Access Compliance Report

Public Rights-of-Way

(Curb Ramps)

Intersection ID: 20718	Main Street: PROVIDENCE_RD	Cross Street: EAST_BARDEN_RD	Location: S
ADA ID: 754993630169	Ramp Type: ParaDiag	Initial Pass/Fail: Fail	Overall Compliance: No
		Severity Score: 13.75

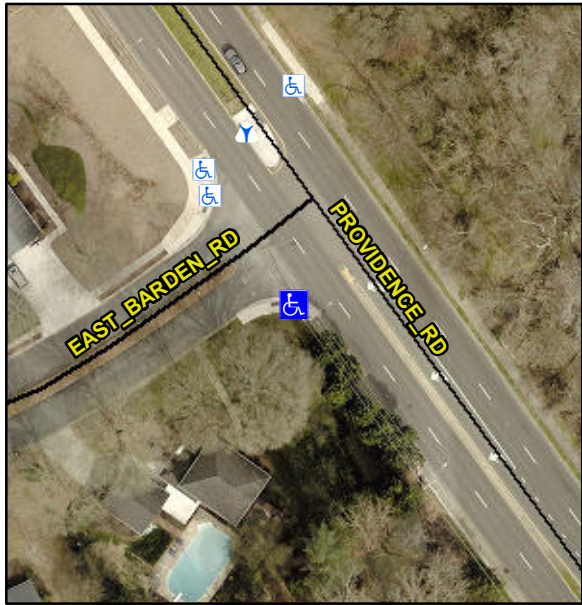
Codes/Mitigation Info/Possible Solution			Field Measurements/Component Compliance		
	Possible Solutions:		Compliance	Description	Data
	Remove & Replace Curb Ramp With Two New Directional Ramps or Equivalent.		N/A	Ramp Length LT (in)	67.0
			Yes	Ramp Width LT (in)	59.0
			Yes	Ramp Slope LT (%)	3.4
			No	Ramp XSlope LT (%)	2.4
			N/A	Landing Length (in)	N/A
			N/A	Landing Width (in)	N/A
			N/A	Landing Slope (%)	N/A
			N/A	Landing X Slope (%)	N/A
			N/A	Landing Curb? (Y/N)	N/A
Surveyor Notes:		Compliance	Description	Data	
LT RP < 5%		N/A	Ramp Length RT (in)	60.0	
		Yes	Ramp Width RT (in)	60.0	
		No	Ramp Slope RT (%)	9.5	
		Yes	Ramp XSlope RT (%)	1.3	
		N/A	DWS Provided?	N/A	
		N/A	DWS Contrast?	N/A	
		N/A	DWS Length (in)	N/A	
		N/A	DWS Full Width?	N/A	
		N/A	DWS Offset (in)	N/A	
PROW/ADA:		N/A	Gutter Slope (%)	N/A	
R304.5.3, R304.3.2		N/A	Gutter X Slope (%)	N/A	
		N/A	Painted X Walk2?	No	
			X Walk 2 Direction	To NW

N/A	X Walk 2 Width (in)	N/A	
			X Walk 2 Slope (%)	6.2	
			X Walk 2 X Slope (%)	3.8	
		N/A	Ramp inside XWalk2?	N/A	
		N/A	Clear Space?	N/A	
		N/A	Clear Space to XWalk (in)	N/A	
		N/A	Storm Grate/Utility Hazard?	N/A	
			Storm Grate/Utility Type		
Total Cost:		N/A		N/A	
		Yes	Surface Condition? (G/P)	Good	
		N/A	Curb Slope (%)	5.3
